Thesis Changes Log

Name of Candidate: Timur Yagafarov

Title of Thesis: Polariton lasing in a dye-filled organic microcavities

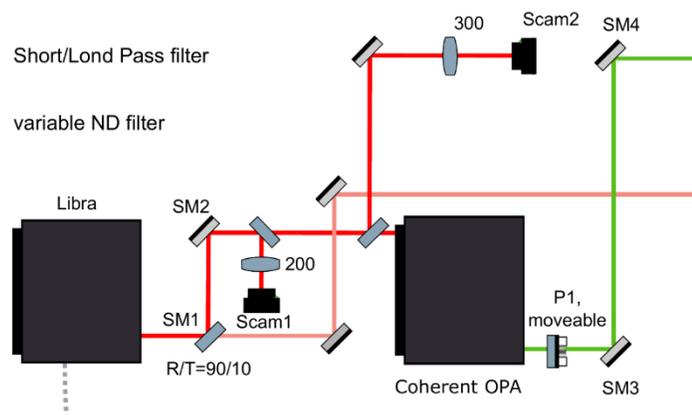
• *In Fig. 3.6 there is a black box that is not identified (the one on the right)*

Thanks for the correction! The “Coherent optical parametric amplifier system” has been identified in Figure 3.6 (Page 49).

Additional reference for the Figure 3.6 was made in the description of Z-scan measurement, where we used the Coherent OPA system: "...pumped the optical parametric amplifier (Coherent OPerA SOLO, see in Figure 3.6) and provided 550 nm central emission wavelength..." (Page 69)

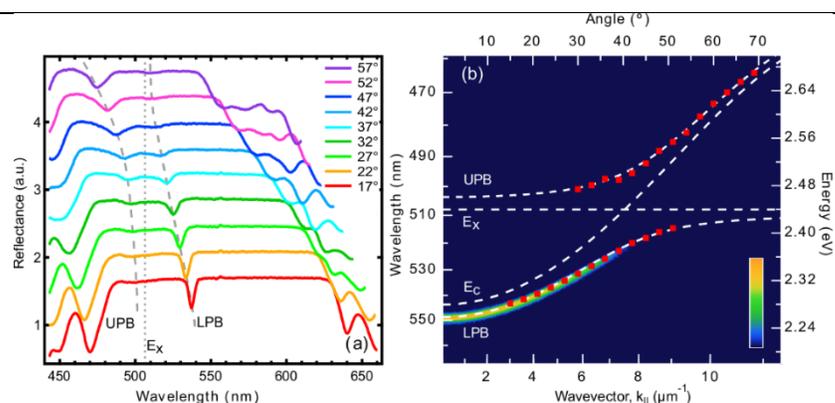
- *Fig. 4.3. Do the data plotted in (b) correspond to those of (a), it does not look like that this is the case. I have added the cyan lines to the graphs, and, for example, at 24° I believe that what is plotted in (b) does not correspond to what is shown in (a).*

Yes, that is true, thanks for the correction. The reflectivity spectra were not the same as on the color plot (they were taken from different points). I changed the reflectivity spectra in Figure 4.3 to appropriate one. Also correction was implemented in the text and the legend. (Page 64).
